AMERICAN ENERGY CORPORATION

RE: Response to Comments, Bennoc Area NPDES OIL00159 Application for American Energy Corporation in Belmont County, Ohio

Response to OEPA Comments from Bruce Goff and Eric Nygaard Dated 8/21/12, 8/15/12, 7/20/12, 7/13/12, and 7/11/12 Bennoc NPDES Permit Application OIL00159

Wheel treatment system – pictures provided by www.chemstream.com

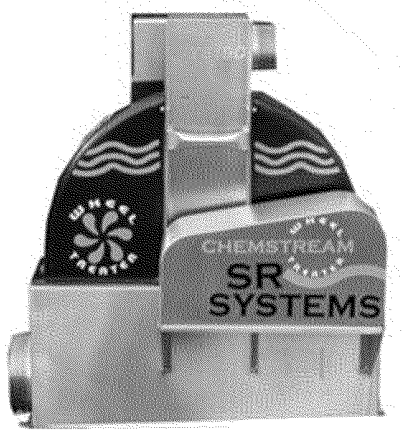
Comment: Do you happen to have any photos of the treatment ponds, the outlet structures, the chemical feed equipment and the discharge drainage ways (outlet ditches) you can share?

Response: We do not have any pictures of the proposed treatment ponds and their structures. However, we do have a picture (below) of the proposed wheel treatment system.

Section A'-A

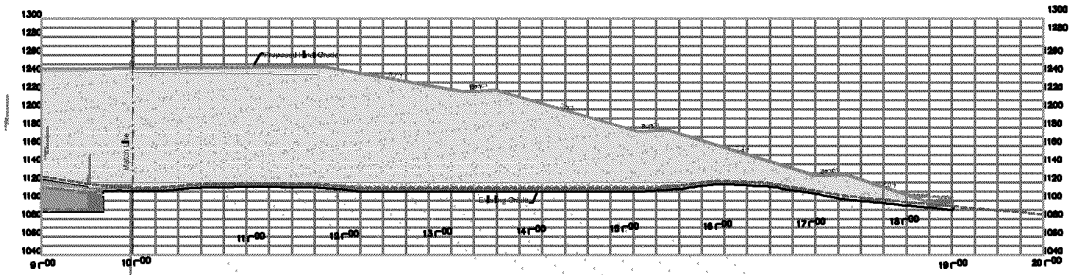
Comment: Also send us some typical cross sections of the refuse disposal area. Include a cross section before disposal of refuse, a cross section during disposal and a final cross section showing final grades and reclamation.

Response: Cross sections of the area for before disposal and after reclamation can be found in the attached drawing Sections A'-A & B'. During disposal cross-sections would be difficult to supply due to the constant change during construction.
